State of New Mexico
Energy, Minerals and Natural Resources

SUNDRY NOTICES AND REPORTS ON WELLS

2. Name of Operator
Yates Petroleum Corporation

Well Name & Number: Ric #2

BEFORE

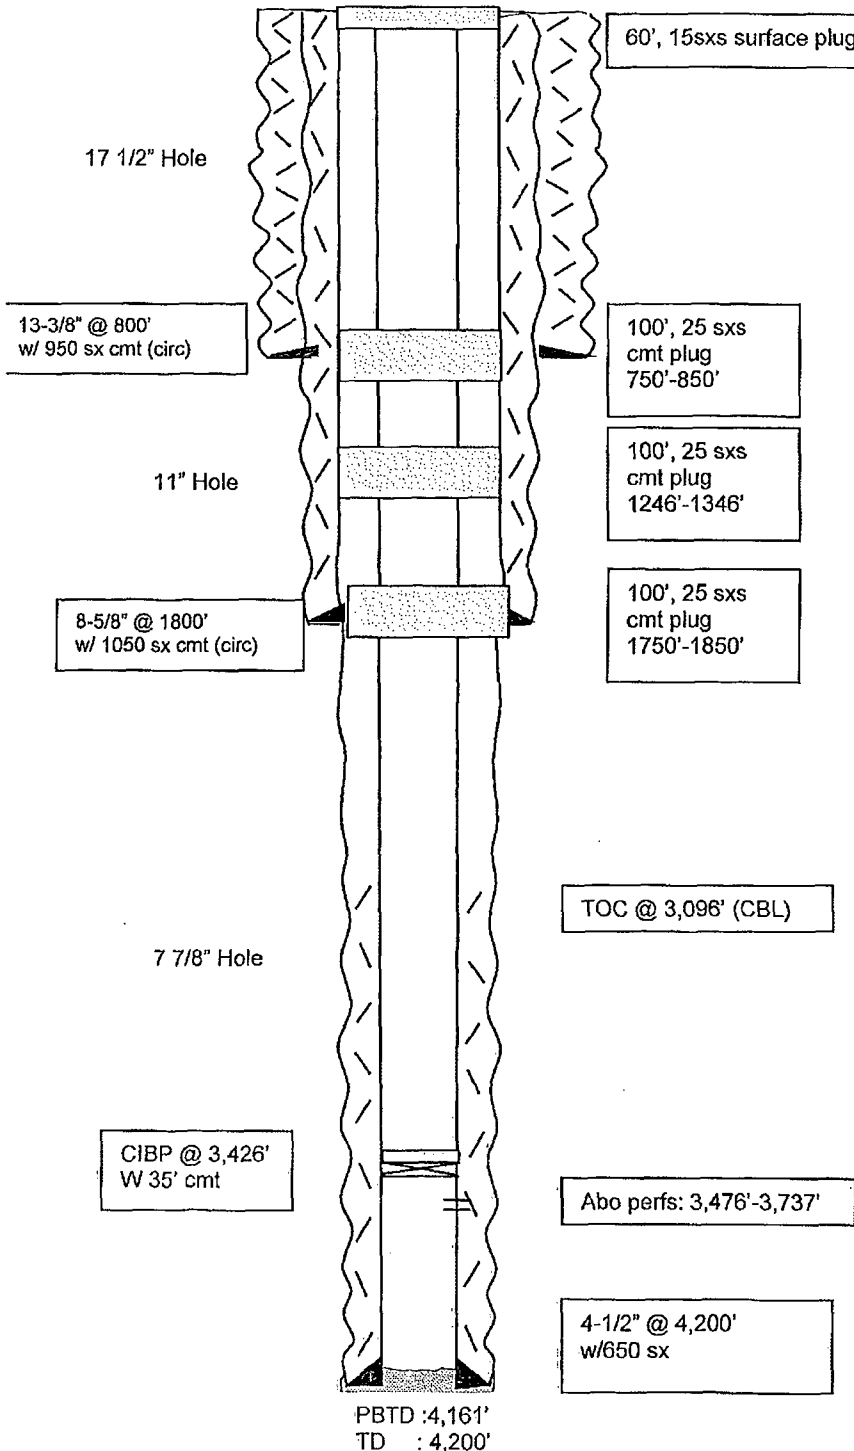
1. MIRU any safety equipment as needed. No casing recovery will be attempted. TOH with production string.
2. Set a CIBP at 3426' with 35' cement on top. This will put a plug over Abo perms and across top of the Abo.

3. Perforate and spot a 25 sx Class "C" cement plug from 1750'-1850'. This puts 100' cement plug across Intermediate casing shoe, outside and inside casing. WOC and tag plug.

4. Perforate and spot a 25 sx Class "C" cement plug from 1246'-1346'. This puts 100' cement plug across top of the Glorieta, outside and inside casing.

5. Perforate and spot a 25 sx Class "C" cement plug from 750'-850'. This puts 100' cement plug across surface casing shoe, outside and inside casing. WOC and tag plug.

6. Perforate and spot a 15 sx Class "C" cement plug from 60' up to surface, outside and inside casing.
7. Remove all surface equipment, weld dry hole marker and clean location as per regulations.

1. Produced water **will not** be used during any part of the plugging & abandonment operation.
2. Notify NMOCD Dist. 2 office at least 24 hrs before beginning work.

7. Every attempt must be made to clean the well bore out to below the perms, before any plugs can be set, by whatever means possible.
8. **Cement Retainers may not be used.**

9. Squeeze pressures are not to exceed 500 PSI, unless approval is given by NMOCD.

10. Plugs may be combined after consulting with and getting approval from NMOCD.

11. Minimum WOC time for tag plugs will be 4 Hrs.
